FCT SERVICE NOTE
SN06101714b

Subject: VCT Detector Module Open Pixel Faults

Effectivity: VCT VDAS32 and 64 systems and HDAS systems

Figure 1: Flex connection screws (3)

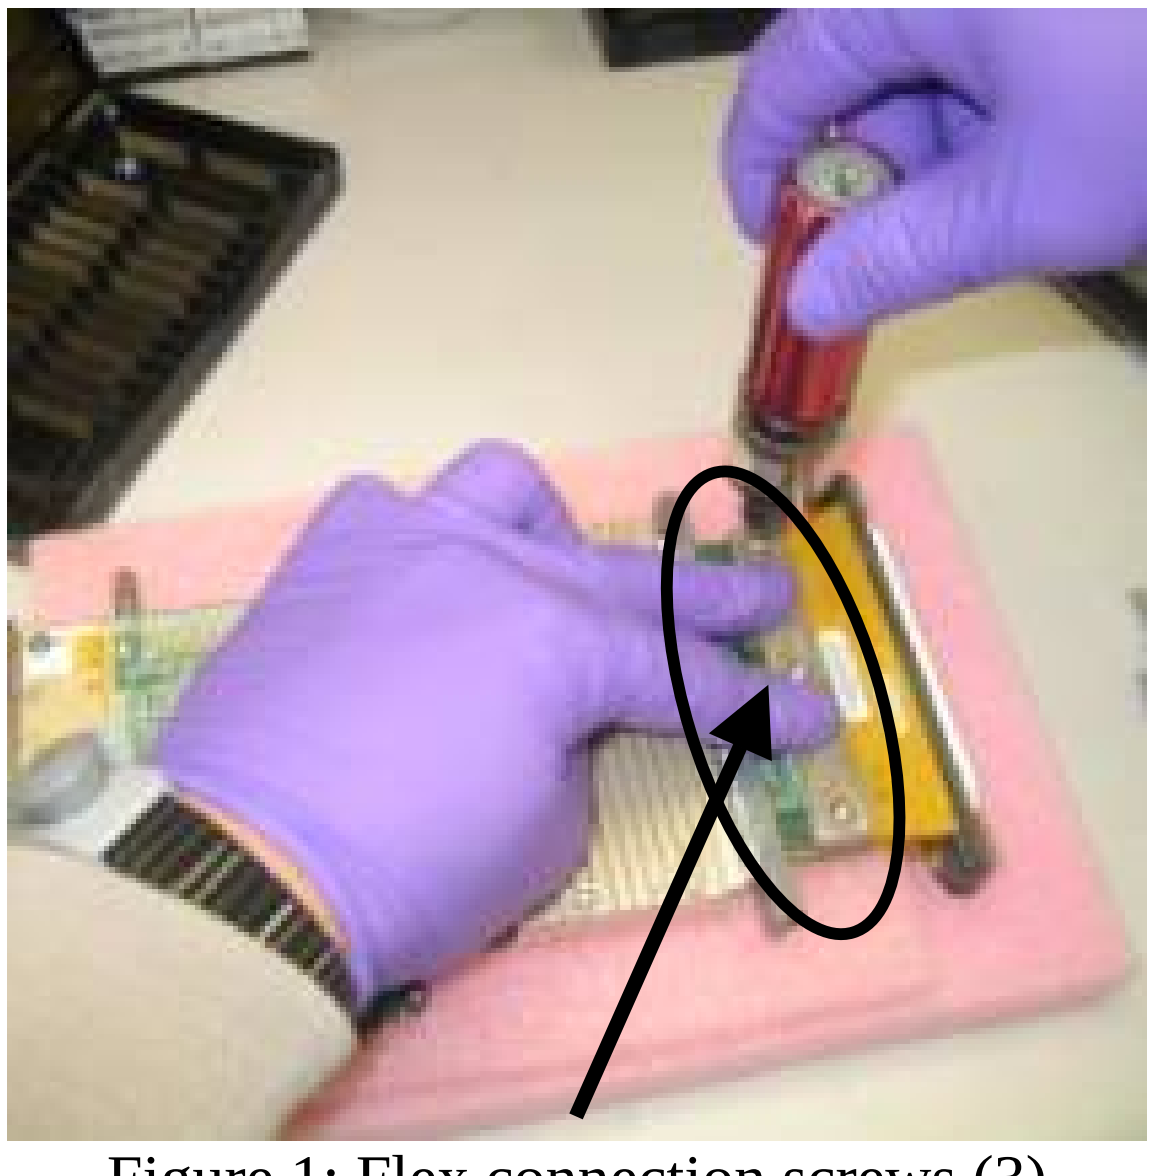
Details:
Almost all incidents of “OPEN” pixel faults have been found to be flex clamp screw torque issues. The screws for the flex clamp on digital modules can become loose over time. Shorted pixel faults are not caused by this issue. Using this procedure to re-torque the flex connection screws for Open Pixel faults can save the expense of a new module in most cases.
32 slice systems and early 64 slice systems require a 2 mm driver bit along with your Torque Driver. 64 Slice systems shipped in 2006 use a T10 torx bit size.

- Pull the module out per replacement procedure.
- Torque the 3 flex connection screws to 4 lb-in (0.5 N-m or 4.6 kg-cm) starting with the center screw.
- Put the Module back in and Plenum on per standard service instructions.
- Run maratio’s test from DASTools to see if problem has been resolved.

If this does not fix the issue, then replace the module.
Full calibrations will still be required in all cases since a module has been moved.
